SERVICE BULLETIN

APPLICABILITY: 2015MY WRX and STI Models
SUBJECT: Paint Chipping Due To Trunk Lid Movement

NUMBER: 12-172-14R
DATE: 07/11/14
REVISED: 07/15/14

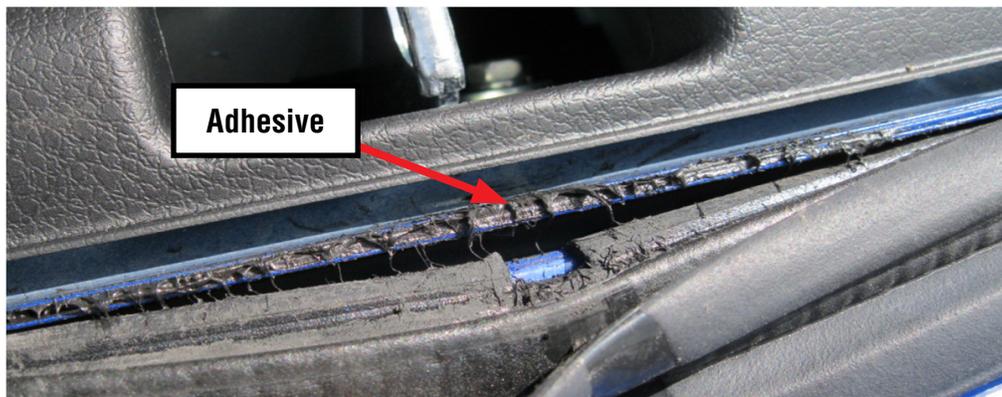
For STI models, in addition to the longer trunk stoppers, the trunk weatherstrip's tubular sealing portion now has internal reinforcement in the area between the red arrows shown in the photo below. This reinforcement serves to stabilize the trunk panel and eliminate the chipping.

- Updated trunk weatherstrip, p.n. **57532VA002**- Qty. 1
- Replacement Trunk Lid Stoppers - Qty. 2
 (NOTE: currently, these are BRZ trunk stoppers, p.n. **57533FE040**)

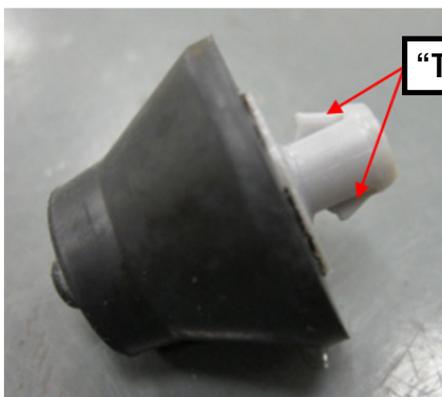
STEP 1: (Both WRX and STI Models) Replace both the rubber trunk stoppers with the longer version (currently used on BRZ, p. n. **57533FE040**). The photos show the current stopper on the left and the replacement longer version installed in position on the right. Use a plastic trim tool between the stopper and the trunk panel to release the 2 “tang” holding the original stoppers in place.

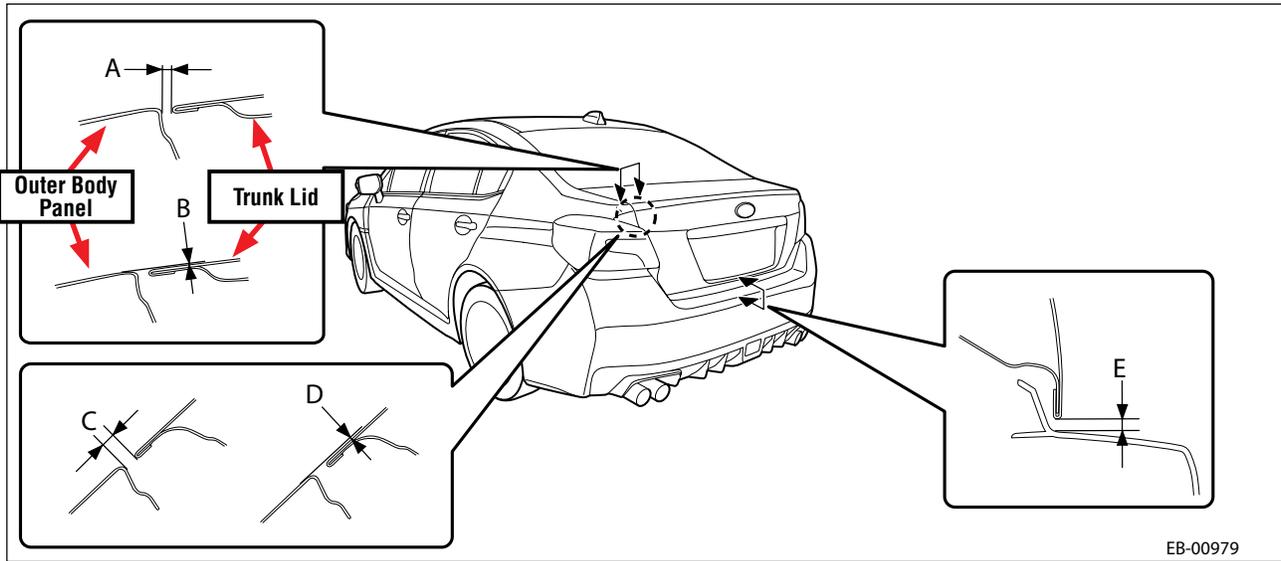
As shown in the photos below, align the square notch with the trunk latch striker. The arrow molded into the short, smooth portion of the trunk weatherstrip faces down toward the bumper cover. On the top section (closest to the back glass), the blue dot should align with the center of the third brake light.

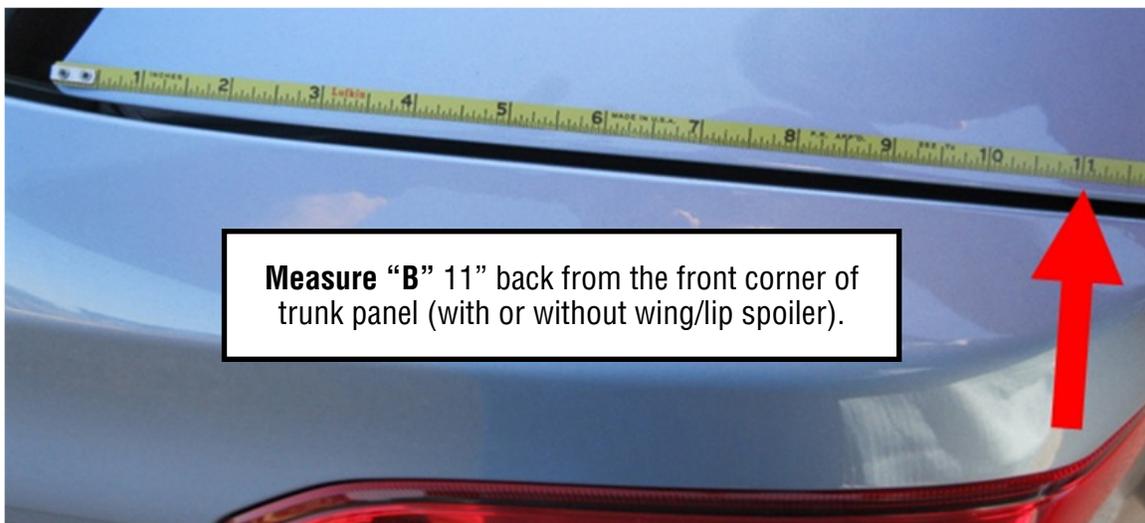
- After the trunk lid is closed, look closely for any excessive, insufficient or uneven gap(s) around the complete perimeter of the trunk lid.
- Make sure the trunk height is correct and that it fits “flush” with the corresponding edges of the rear quarter panels.
- In most cases, there should be only **minor** adjustment needed to the trunk lid, if any at all. Pay close attention to the adjustment for “**B**” as shown in the table below. If after close inspection, it is determined adjustment of the trunk lid is necessary for proper fit, use the Service Manual specifications supplied below **EXCEPT FOR “B”** which has been recently revised (shown in RED). The Service Manual will be updated with the revised specifications in the near future.

- Clearance “A” and “C” must be the same left to right.
- If “D” and “E” are within the specifications listed in the tables above, no adjustments are necessary.

Part		Standard
A	Trunk lid COMPL and Panel - side outer	3.5±1.0 mm (0.14±0.04 in)
B	Surface level gap between Trunk lid COMPL and Panel - side outer (Difference in height)	0+.5 mm (.020") by adjusting the striker -STI
C	Trunk lid COMPL and Panel - side outer	3.5±1.0 mm (0.14±0.04 in)
D	Surface level gap between Trunk lid COMPL and Panel - side outer	-0.5±0.7 mm (0.02±0.03 in)
E	Trunk lid COMPL to Bumper face - rear	7.5±1.0 mm (0.3±0.04 in)

Part		Standard
A	Trunk lid COMPL and Panel - side outer	3.5±1.0 mm (0.14±0.04 in)
B	Surface level gap between Trunk lid COMPL and Panel - side outer (Difference in height)	-1.0 mm (.040") by adjusting the striker -WRX
C	Trunk lid COMPL and Panel - side outer	3.5±1.0 mm (0.14±0.04 in)
D	Surface level gap between Trunk lid COMPL and Panel - side outer	-0.5±0.7 mm (0.02±0.03 in)
E	Trunk lid COMPL to Bumper face - rear	7.5±1.0 mm (0.3±0.04 in)
